**Eastern Corridor Segments II and III
Red Bank Corridor to I-275/SR 32 Interchange (PID 86462)
Public Open House
Meeting Summary Report**

**October 24 and 25, 2018 Public Open House
MEETING SUMMARY REPORT**

**October 24 and 25, 2018 Public Open House
CONCEPT EVALUATION and COMMENT SUMMARY**

SR 125/SR 32 FOCUS AREA CONCEPTS A9, A10 AND A11, BOARD 7

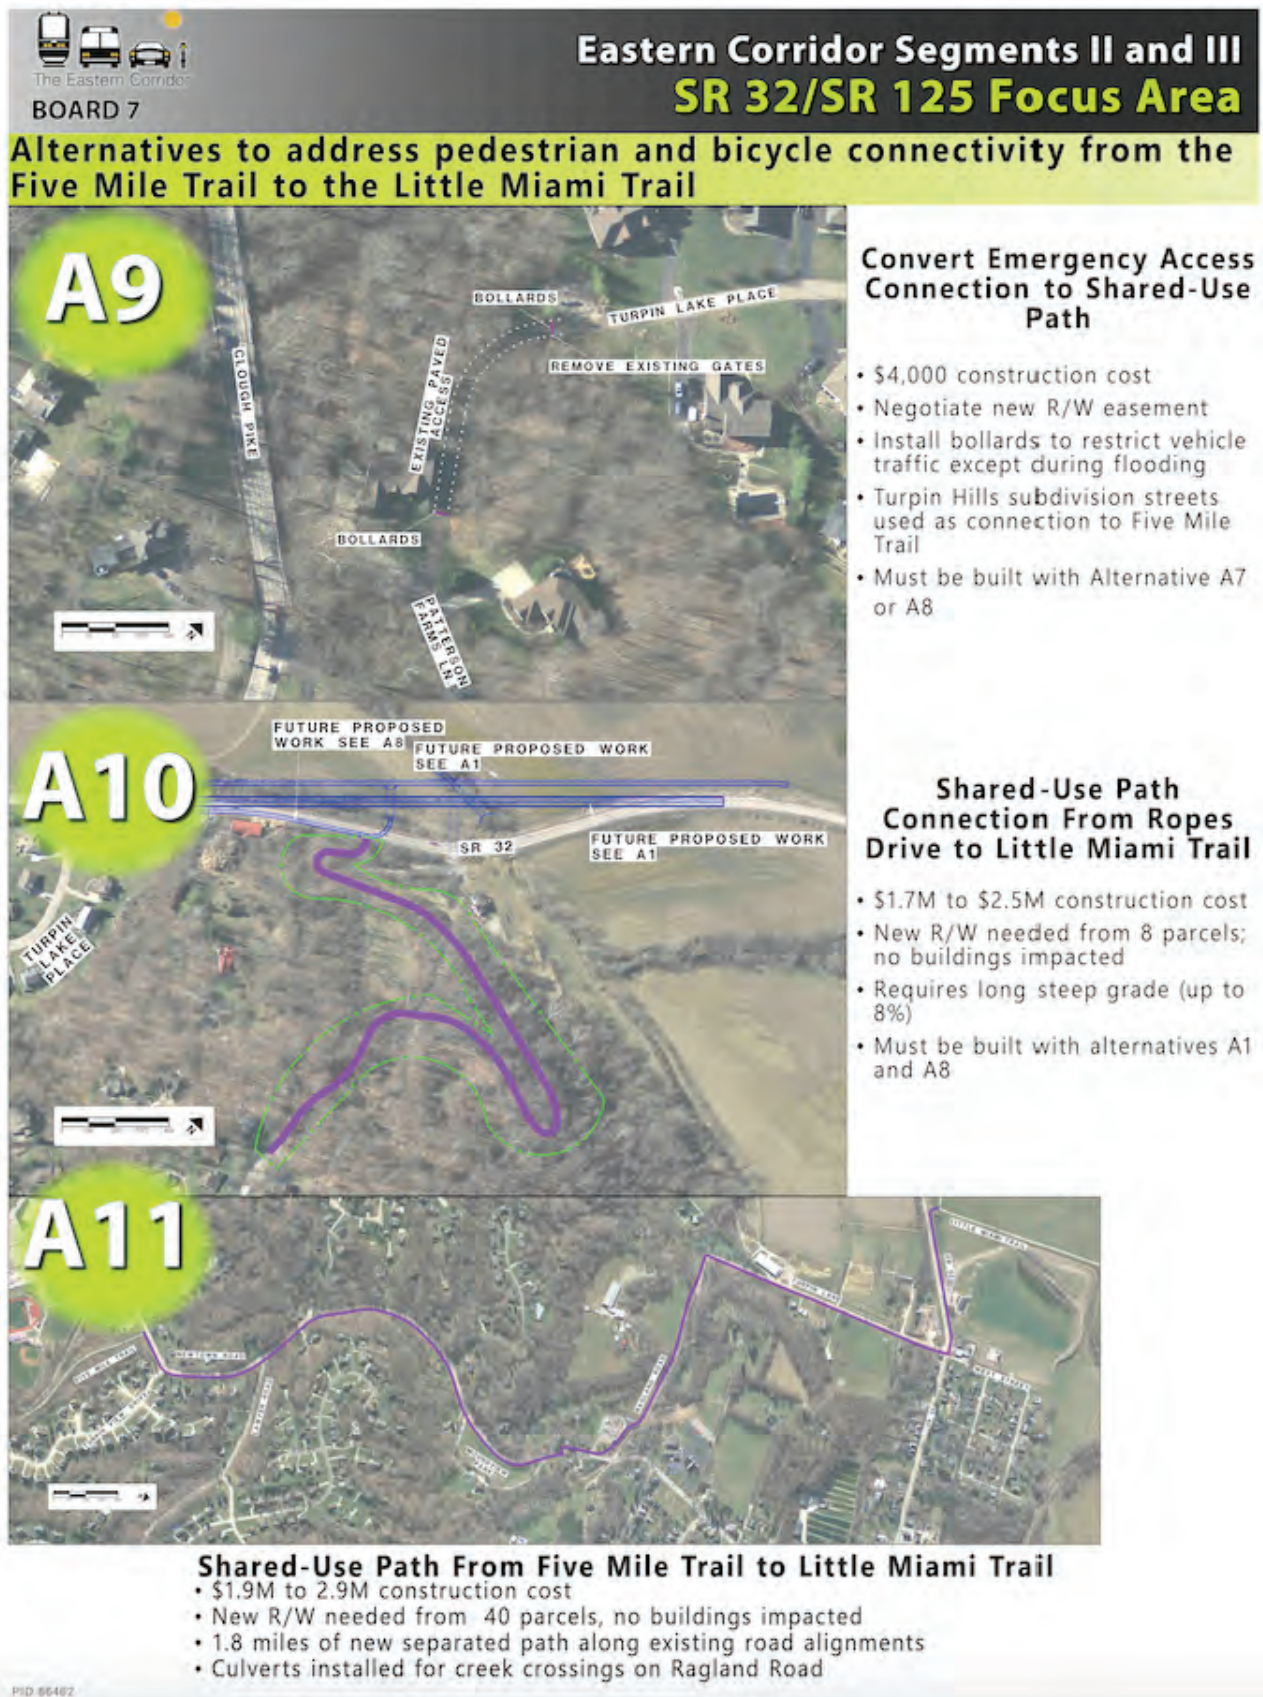
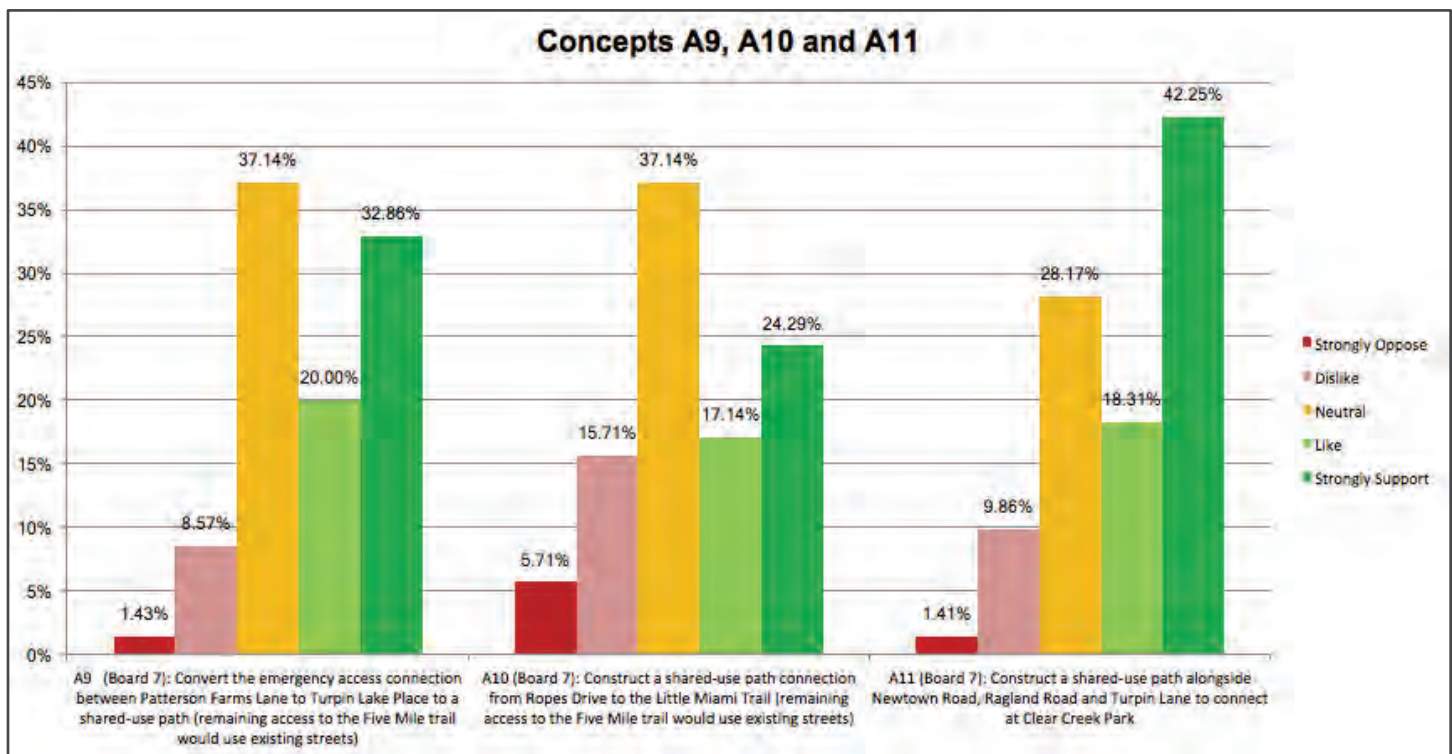
NO.	COMMENT	RESPONSE
1	A, 9,10, 11 - Very Low Priority	Thank you for your comments. Your input is appreciated and will be taken into consideration as we evaluate the options and develop our recommendations.
2	A9 - Like cost effective, short term fix.	Thank you for your comments. Your input is appreciated and will be taken into consideration as we evaluate the options and develop our recommendations.

NO.	COMMENT	RESPONSE
3	A9 - this makes more sense than A10! But neither is needed!	Thank you for your comments. Your input is appreciated and will be taken into consideration as we evaluate the options and develop our recommendations.
4	<i>Received via email:</i> A9 - It is not clear how A9 connects to Five Mile Trail. It seems to be the most cost effective and keeps pedestrians / bicyclists out of heavier traffic though which is desirable.	Thank you for your comment. This concept connects Five Mile Trail to the Little Miami Trail by using subdivision streets in Turpin Hills to the end of Patterson Farms Lane, and then utilizing the existing emergency access road connecting to Turpin Lake Place. The connection would then use the roadway to SR 32. A crossing of SR 32 would then be established to link up to the Little Miami Trail.

NO.	COMMENT	RESPONSE
1	A, 9,10, 11 - Very Low Priority	Thank you for your comments. Your input is appreciated and will be taken into consideration as we evaluate the options and develop our recommendations.
2	Prefer A11 over A10 - connects to more residents	Thank you for your comments. Your input is appreciated and will be taken into consideration as we evaluate the options and develop our recommendations.
3	A10 - This alternative should be eliminated due to A9, a much lower cost alternative, will serve this neighborhood.	Thank you for your comments. Your input is appreciated and will be taken into consideration as we evaluate the options and develop our recommendations.
4	A10 - absolutely NOT needed!	Thank you for your comments. Your input is appreciated and will be taken into consideration as we evaluate the options and develop our recommendations.

NO.	COMMENT	RESPONSE
3	A11 – who	<i>Comment appears to be incomplete; no response needed.</i>
4	All Board 7 - This section uses creek bed for a portion of Ragland Rd. Turpin Lane currently floods in heavy or prolonged rains. It also floods when Vineyard Hills golf course pumps out its retaining pond-- which extends the amount of time Turpin Lane is flooded and/ or barely passable.	Thank you for your comment. Flooding in this area is a concern, and we appreciate the additional information you have shared. Your input will be taken into consideration as we develop our recommendations.

Add an additional westbound lane on SR 32 through the Church and Main intersection

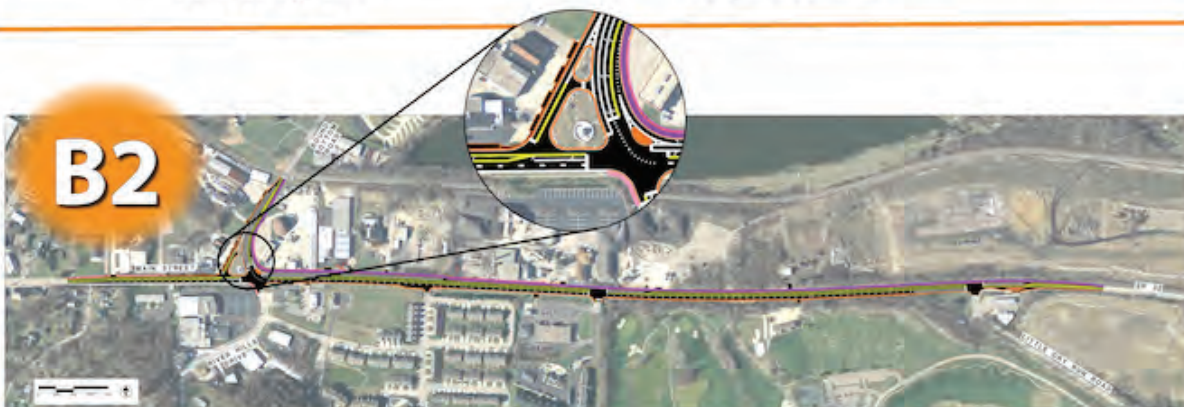
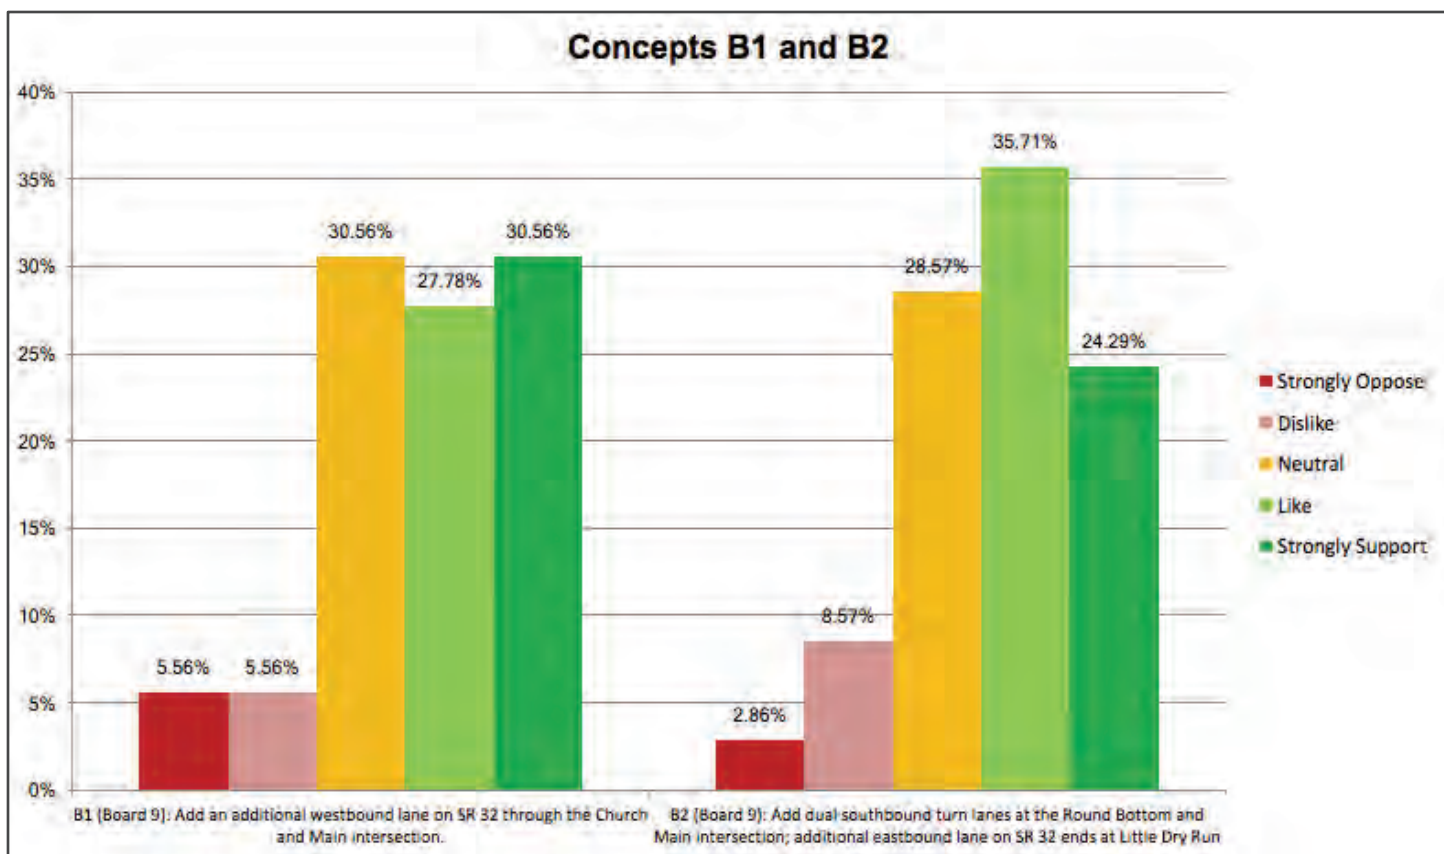
NO.	COMMENT	RESPONSE
1	B1 - Would destroy walkability and historic feel of Newtown.	Thank you for your comment. This has been a concern of the Advisory Committee as well and maintaining walkability has been identified as a priority. We will keep this aspect in mind as we develop recommendations to be included in the Implementation Plan. Also, additional community involvement will be necessary before any final decisions regarding construction are made.

VILLAGE OF NEWTOWN FOCUS AREA CONCEPTS B3, B4 AND B5, BOARD 10

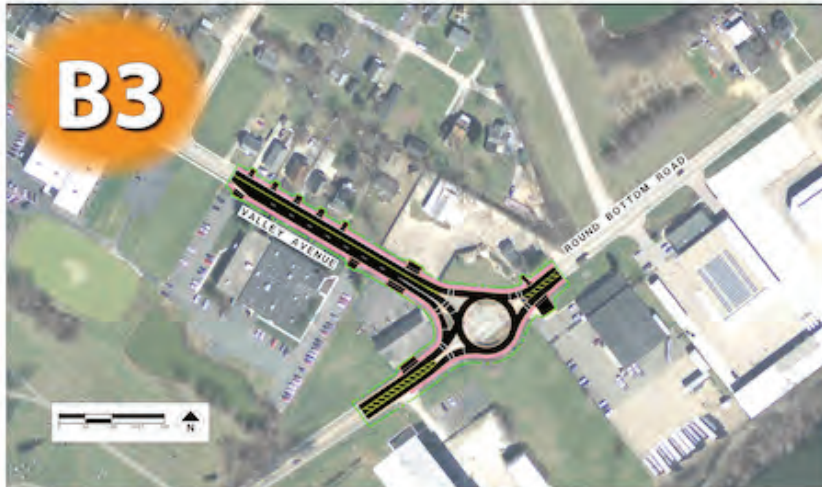
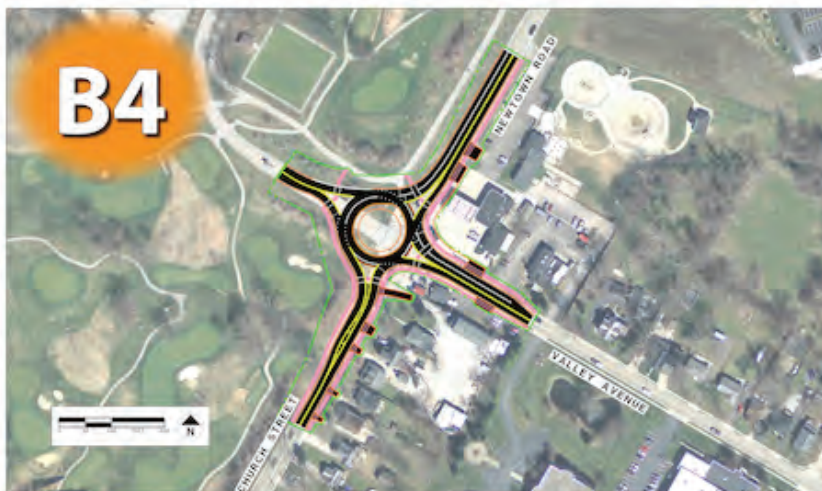
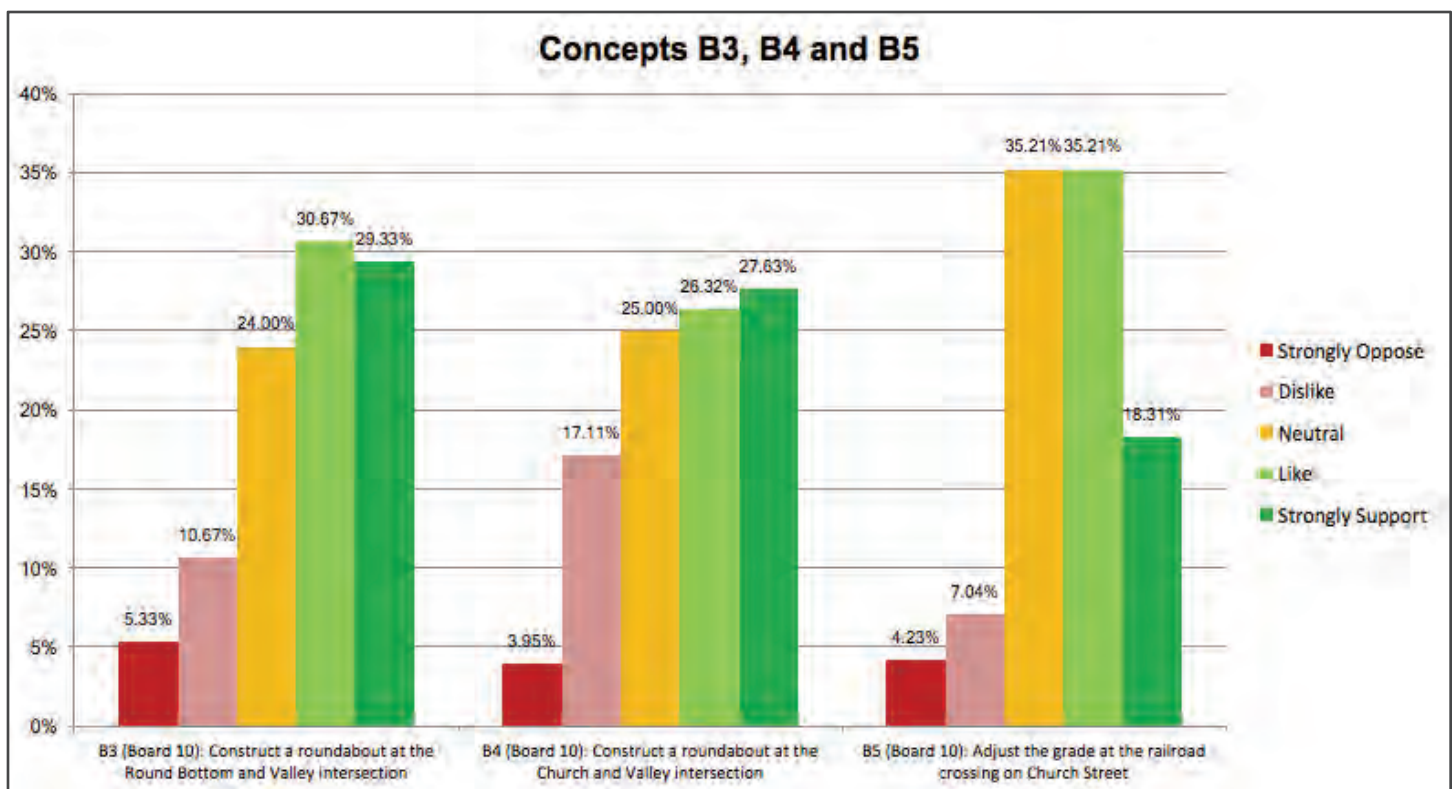
NO.	COMMENT	RESPONSE
1	Regarding B3 - the roundabout is not needed. Installing a better traffic sensor would solve the problem.	Thank you for your comments. Your input is appreciated. Adding traffic sensors to the existing signals is a short-term recommendation of this study and is being pursued. The resulting improvement from that installation will be analyzed to determine if this concept would still be needed.
2	Installing roundabouts could impact getting in and out of business along valley and it will make Valley even more traveled and folks will go even faster	Thank you for your comments. Your input is appreciated and will be taken into consideration as we evaluate the options and develop our recommendations.
3	The traffic at Round Bottom and Valley is going to be a disaster! Too many trucks	Thank you for your comments. A roundabout at this location would be designed to accommodate trucks using this intersection.

NO.	COMMENT	RESPONSE
1	Regarding B4 - same as above [the roundabout is not needed. Installing a better traffic sensor would solve the problem].	Thank you for your comments. Your input is appreciated. Adding traffic sensors to the existing signals is a short-term recommendation of this study and is being pursued. The resulting improvement from that installation will be analyzed to determine if this concept would still be needed.
2	Installing roundabouts could impact getting in and out of business along valley and it will make Valley even more traveled and folks will go even faster.	Thank you for your comments. Your input is appreciated and will be taken into consideration as we evaluate the options and develop our recommendations.

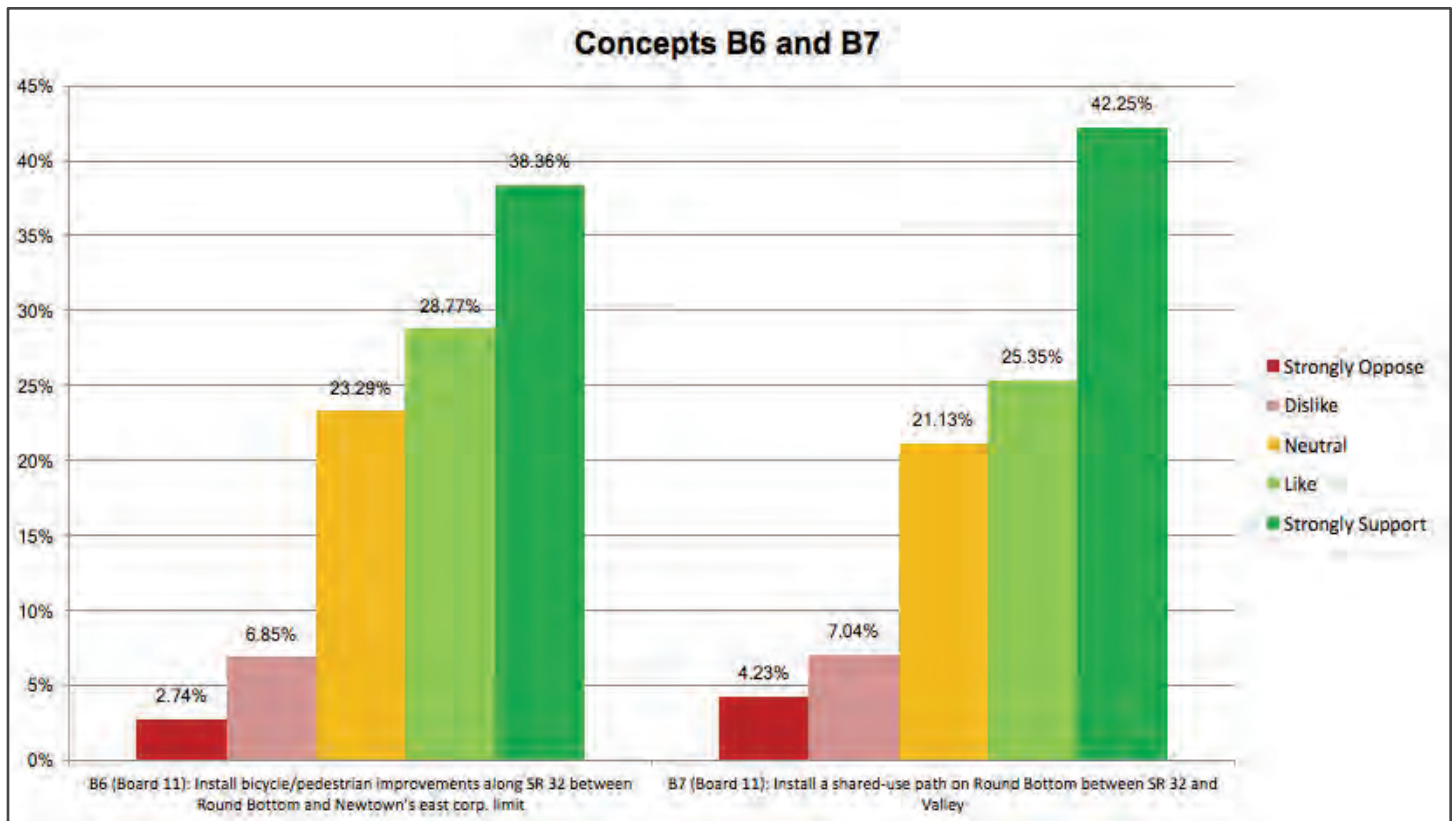
NO.	COMMENT	RESPONSE
1	B6 - Would like to see need assessment	The Eastern Corridor Segments II and III Transportation Needs Analysis Report (July 2017) is posted on the Segments II and III Public Involvement page of the Eastern Corridor website, www.EasternCorridor.org .
2	B6 and B7 - It is unclear who this would serve. Minimal residents and businesses through this corridor that would be benefited by a pathway.	Thank you for your comments. Concepts B6 and B7 were proposed to help address bicycle and pedestrian connectivity needs. More specifically, B6 would provide bicycle and pedestrian connectivity from downtown Newtown to its east corp. limit, connecting users to commercial development at and near Burger Farm and residential communities along Little Dry Run Road.

NO.	COMMENT	RESPONSE
		Concept B7 would improve bicycle and pedestrian connectivity along Round Bottom Road, which also can be connected to additional segments along Valley Avenue or extend on to Riverside Park or Lake Barber.
3	B6 - Strong support for the Little Dry Run to Round Bottom section. Little Miami Trails - couldn't easily connect to Anderson Trails project with this piece of the project.	Thank you for your comments. It should be noted that projects such as B6 would serve as smaller pieces of a larger connectivity effort that has to be constructed in stages due to funding limitations
4	I live in Williams Creek, which connects through Ivy Hills to a sidewalk along Little Dry Run. The sidewalk leads to the Clark Station on SR32. We feel isolated from the business Districts in Newtown & Anderson. Bicycle and pedestrian improvements along SR32 B6 would be wonderful!	Thank you for your comments. Your input is appreciated and will be taken into consideration as we evaluate the options and develop our recommendations.

NO.	COMMENT	RESPONSE
1	B6 and B7 - It is unclear who this would serve. Minimal residents and businesses through this corridor that would be benefited by a pathway.	Thank you for your comments. Concepts B6 and B7 were proposed to help address bicycle and pedestrian connectivity needs. More specifically, B6 would provide bicycle and pedestrian connectivity from downtown Newtown to its east corp. limit, connecting users to commercial development at and near Burger Farm and residential communities along Little Dry Run Road. Concept B7 would improve bicycle and pedestrian connectivity along Round Bottom Road, which also can be connected to additional segments along Valley Ave or extend on to Riverside Park or Lake Barber.
